Access Compliance Report

Public Rights-of-Way

(Curb Ramps)

Intersection ID: 31303	Main Street: CANSO_CT	Cross Street: DEERTON_RD	Location: N
ADA ID: 9BBC0D87B21C	Ramp Type: PerpDiag	Initial Pass/Fail: Fail	Overall Compliance: No
Codes/Mitigation Info/Possible Solution		Field Measurements/Component Compliance	
Severity Score: 21.25

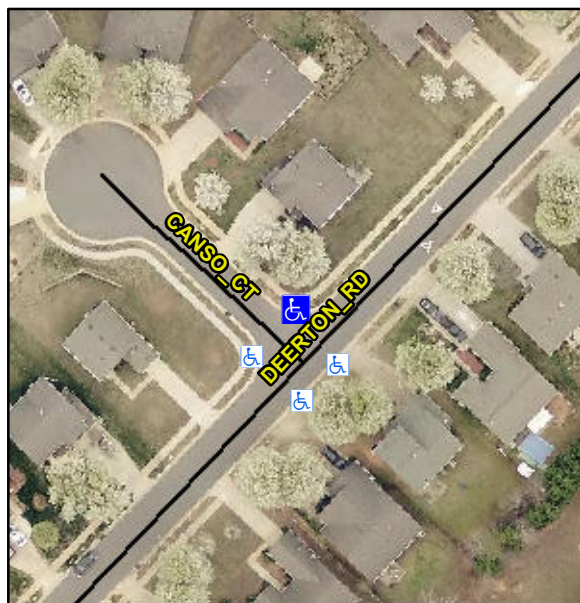
R304.5.1, R304.2.2

Compliance	Description	Data	Compliance	Description	Data
N/A	Ramp Length (in)	48.0	No	Ramp Slope (%)	9.4
No	Ramp Width (in)	46.0	Yes	Ramp XSlope (%)	0.9
N/A	Flare Type LT	N/A	N/A	Flare Type RT	N/A
N/A	Flare Slope LT (%)	N/A	N/A	Flare Slope RT (%)	N/A
N/A	Flare Traversable LT?	N/A	N/A	Flare Traversable RT?	N/A
N/A	Landing Length (in)	N/A	N/A	DWS Provided?	N/A
N/A	Landing Width (in)	N/A	N/A	DWS Contrast?	N/A
N/A	Landing Slope (%)	N/A	N/A	DWS Length (in)	N/A
N/A	Landing X Slope (%)	N/A	N/A	DWS Full Width?	N/A
N/A	Landing Curb? (Y/N)	N/A	N/A	DWS Offset (in)	N/A
N/A	Shared Landing?	N/A			
N/A	Gutter Ponding?	N/A	N/A	Gutter Slope (%)	N/A
N/A	Gutter Lip Ht (in)	N/A	N/A	Gutter X Slope (%)	N/A
N/A	Painted X Walk1?	No	N/A	Painted X Walk2?	No
	X Walk 1 Direction	To W		X Walk 2 Direction	To E
N/A	X Walk 1 Width (in)	N/A	N/A	X Walk 2 Width (in)	N/A
	X Walk 1 Slope (%)	1.0		X Walk 2 Slope (%)	3.0
	X Walk 1 X Slope (%)	0.0		X Walk 2 X Slope (%)	1.6

Remove & Replace Curb Ramp With Two New Directional Ramps or Equivalent.
